Planning Commission Staff Report

Application: PL-17-03526
Subject: Empire Residences
Author: Kirsten Whetstone, AICP, Sr. Planner
Date: October 25, 2017
Type of Item: Administrative - Conditional Use Permit

Staff recommends the Planning Commission hold a public hearing and discuss the Conditional Use Permit for the Empire Residences (Building 3 -Village at Empire Pass Master Planned Development). **Staff requests discussion of 1) side setback reduction requested for balconies on the north elevation and 2) compliance with the VEP MPD Building 3 Volumetric diagram, and continuation to November 29th.**

DRAWING NUMBER
A202

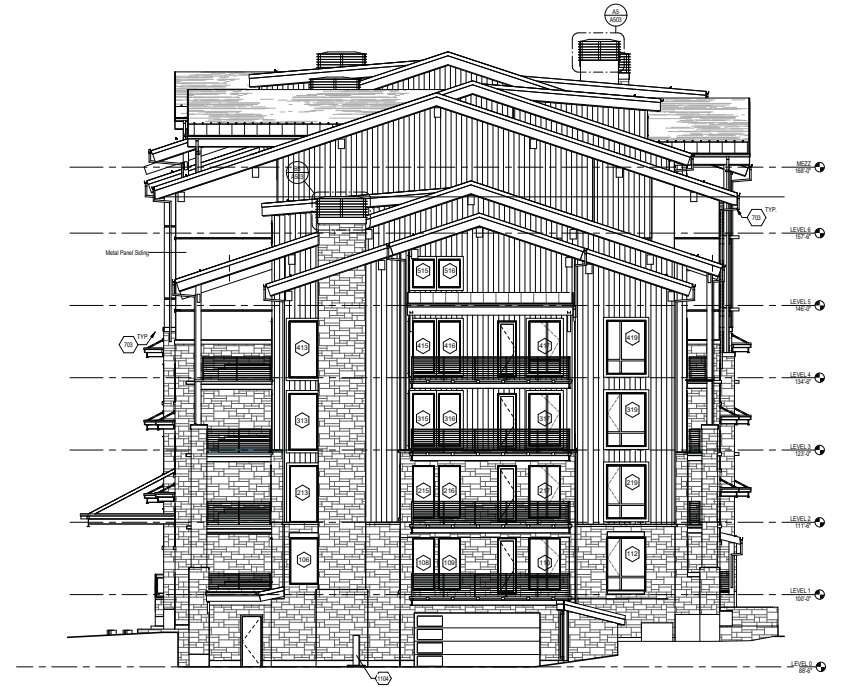
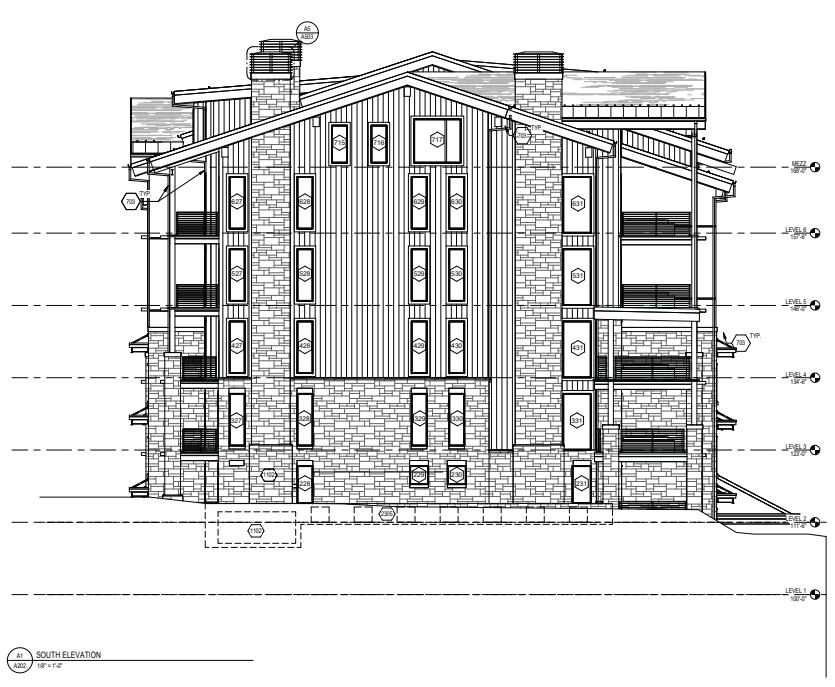
13. Applicant has revised the plans to show the generator underground. The mechanical equipment outside of the affordable unit has been relocated to the sides of the building to maintain a clear deck. Revised location of condensers is shown on elevation sheet A201.

27. The applicant plans show proposed height at 82 feet with a maximum of 82 feet for this lot, and other height limits consistent with approved volumetric for site; Approval subject to PCMC confirmation of height compliance with approved volumetric. In order to meet the 82 foot height restriction the application has modified the roof form and has revised the roof stepping. This additional stepping provides greater interest and compliance with the intent of the building massing. See revised roof on A201-A202
